Author's response to anonymous referees and community comments

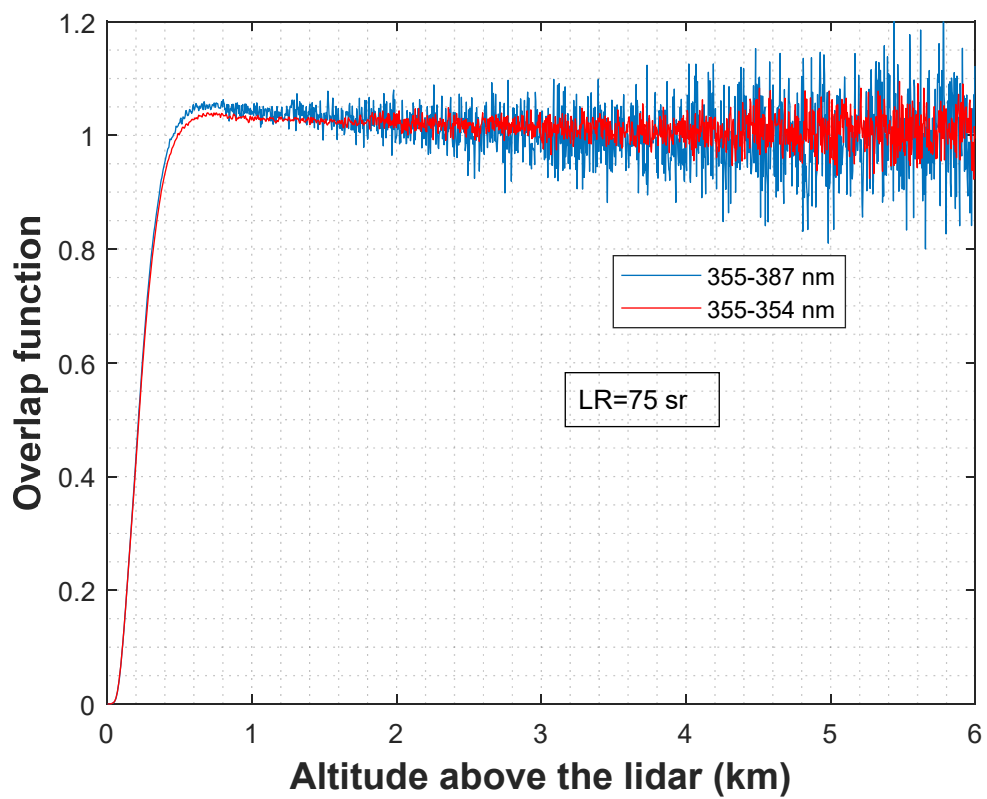
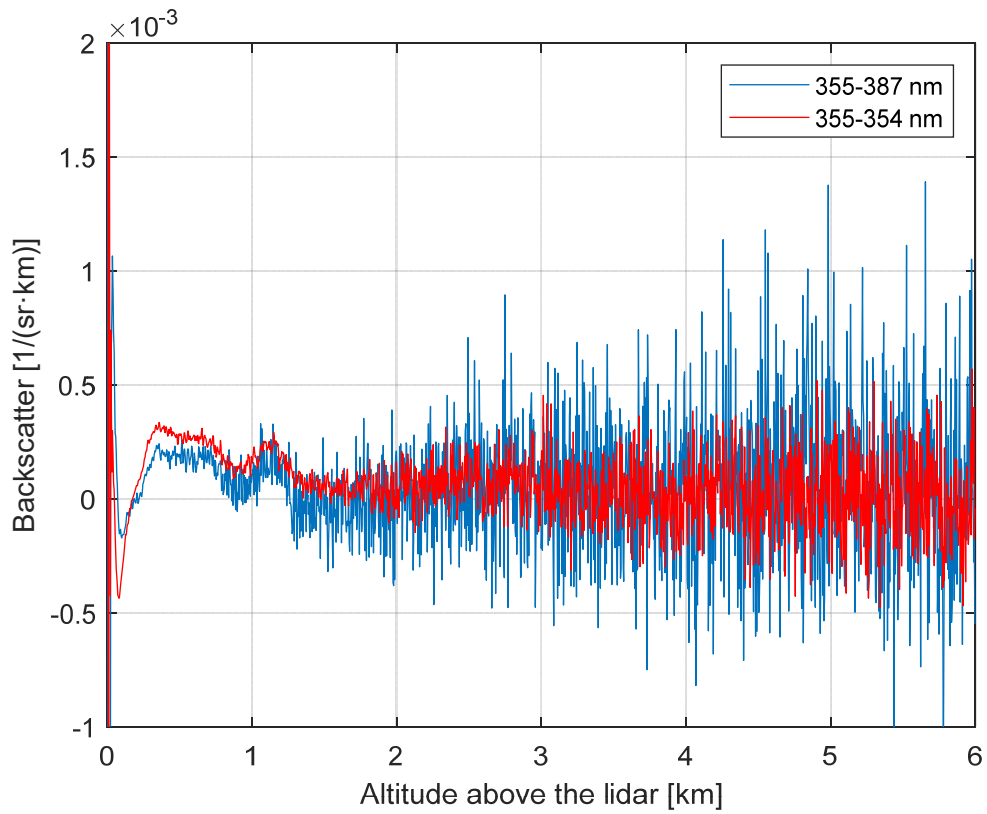
-- The experimental application faces many challenges, such as unrealistic overlap values above the full overlap range and sharp drops to the Raman backscatter profiles below 400m even though they should be, in theory, overlap independent. From my point of view the paper stands just fine with the theoretical part and an experimental application is not necessary. However, if the authors want to include it then they should make sure that:

the overlap between the Raman and the elastic channels is indeed the same. Different interference filters (IFF) are applied per channel that can lead to overlap-like effects in the signals as the angle of incidence (AOI) of the collected beam on the IFF changes from the near range to infinity. This is especially important for the Rotational Raman channel because changes in the AOI create an effect equivalent to shifting the IFF transmission with respect to the incident wavelength. Such overlap-like effects are expected to be pronounced in a Rotational Raman channel due to the proximity of the central wavelength of the IFF to the Cabannes line and due to the temperature dependence of the Rotational Raman cross sections.

A good experimental way of verifying this is to check whether the 355-387 derived overlap is the same as the 355-354 one, or whether the Raman backscatter at 355-354nm is the same in the near range as the 355-387 one. For 532-607nm the authors could prove that by using an IFF with a different bandwidth in subsequent measurements they get the same overlap function. Without such a verification I wouldn't recommend publishing the experimental part.

We are aware of these possible effects.

Nevertheless, we have already given an explanation (included in the paper, lines 249ss) about the values above 1 in the retrieved overlap profile:

1. On the one hand the overlap function value is arbitrarily fixed to 1 at the reference height. This may correspond to a stable overlap condition, but not necessarily to a full overlap one.
2. Because of this if there is a slight crossing between the transmitted beam axis and the receiver field-of-view axis, then an overlap value greater than 1 can be expected.
3. As shown by equation 18 a too low lidar ratio value would lead to enhance overlap values in the zone with aerosol content.

This undesired feature under 400 m in the system was discovered while preparing this work and we are still trying to find out the cause of the issue, as we have recognized in the paper by showing this effect in figure 2.

Regarding the comparison proposed by the reviewer: unfortunately

1. The signal at the VBR 387 nm channel is noisier than the signal from PRR 354 nm. The design of the PRR channel has been carefully made as it was reported in (Zenteno-Hernández et al. 2021). Therefore, we have more confidence in the overlap retrieved with the 354 nm.
2. Using the PRR channel in eq 9 minimizes the effect of discarding the difference in atmospheric transmission between the elastic and Raman channels that is applied in the practical calculation of eq 15

As an example, we have computed the Raman backscatter coefficient at 355 and the overlap retrieval with both Raman channels for the Dec 1st measurement. The reference height is 6 km.

Given the noise in the 387 nm channel, we give more confidence to the calculation using 354 nm.
